Applicants : Scott D. Brandenburg et al.
Appln. No. : 10/624,063
Page : 3

REMARKS

Att. Docket No. DP-309190 (DEL01 P-440)
Appl. No. 10/624,063
Amendment Dated December 21, 2005
Reply to Office Action Mailed September 21, 2005
Annotated Sheet 1 of 2 Showing Changes

FIG. 2

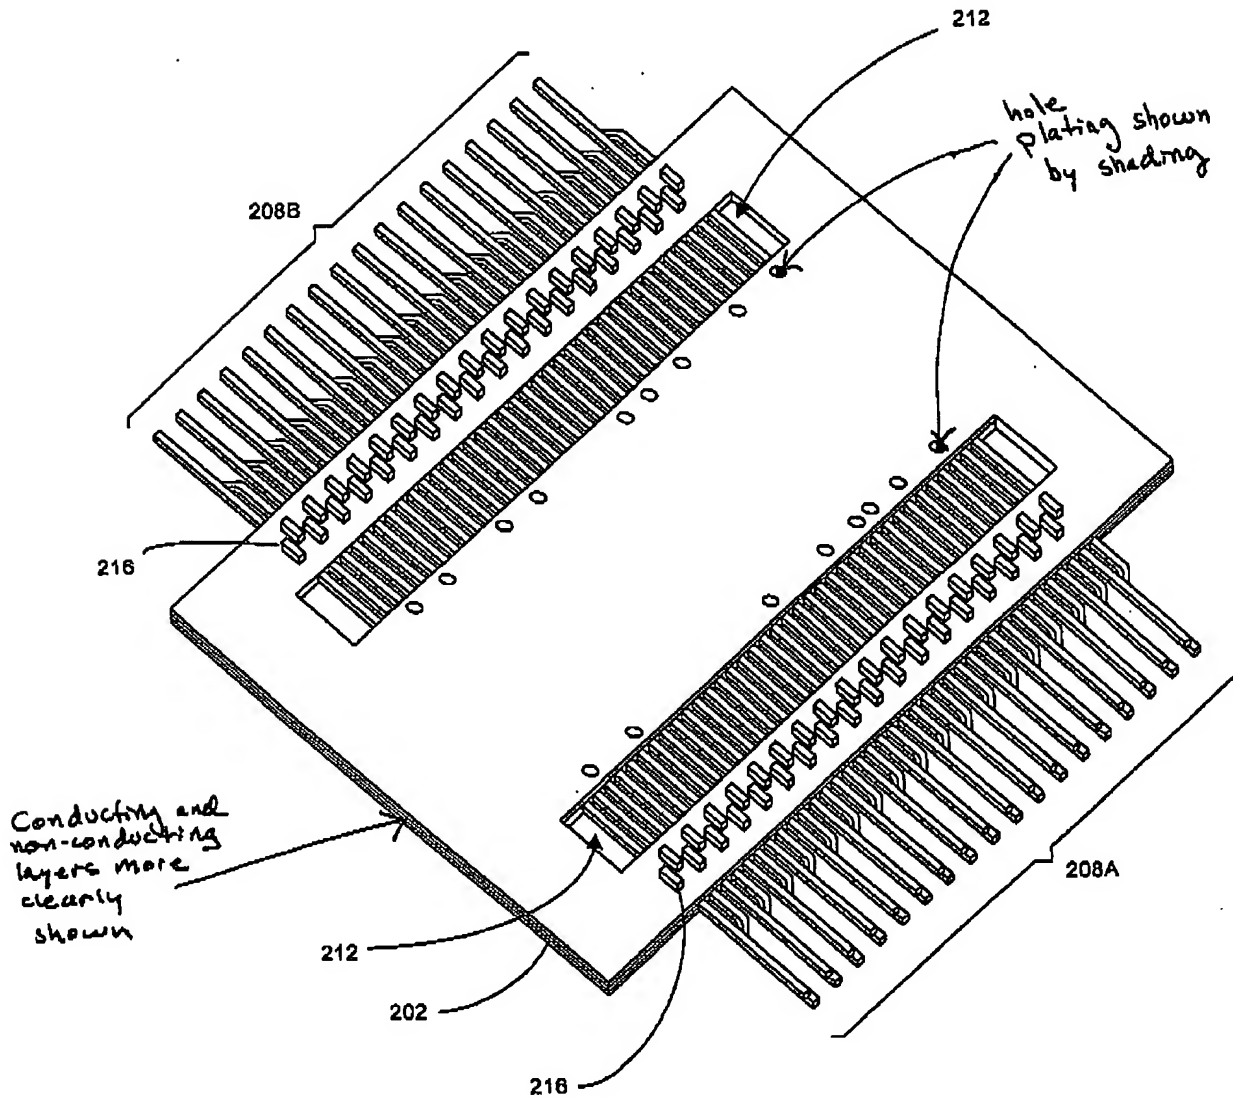
In the present non-final Office Action, the Examiner objected to the drawings under 37 C.F.R. § 1.83(a). Applicants have provided corrected drawing sheets clearly showing the PCB including a plurality of conductive layers, each separated by a non-conducting layer, at least one conductive trace of the PCB "plated through [sic] holes," and an automotive assembly. Because these elements were already disclosed in the claims and specification, the changes made to the drawings do not introduce new matter. Applicants respectfully submit that, with these changes, the drawing objection is now moot and the drawings are in condition for acceptance. Therefore, Applicants respectfully request that the objection to the drawings be withdrawn.

The Examiner also stated that "the drawings do not support for the claimed invention." As noted above, Applicants have corrected the drawings to satisfy the Examiner by showing an automotive assembly. Based on the foregoing discussion, Applicants respectfully submit that the rejection of claims 16-21 under 35 U.S.C. § 112, first paragraph, should be withdrawn for at least these reasons.

AUTOMOTIVE ASSEMBLY SHOWN

The attached sheets of drawings include changes to Figs. 2 and 2A. The replacement sheets, which include Figs. 2 and 2A, replace the original sheets including Figs. 2 and 2A.
